NEVE/CCU Installation

DATE: 07/25/94
MODEL: Console Control Unit
REVISION: All
SERIAL NO: All
SOFTWARE: CCU 230 and later
SSU 140 and later

DESCRIPTION:

An update is required in the Neve Flying Faders configuration file. This update improves CCU performance in Neve/SSU installations.

Figure 1. Jumper Location

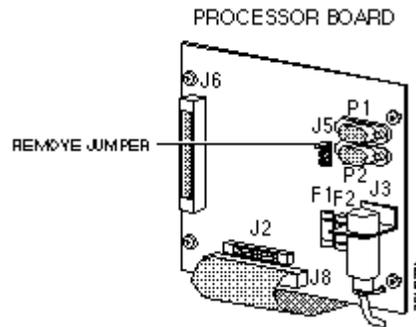
1. Turn off the CCU and remove the jumper between pins 1 and 2 of CCU Header J5.
2. Power up the CCU while holding the CLR Key to reset the CCU.
3. Under [SETUP] + [SYS] on the CCU, check that control Via is set to DIRECT.
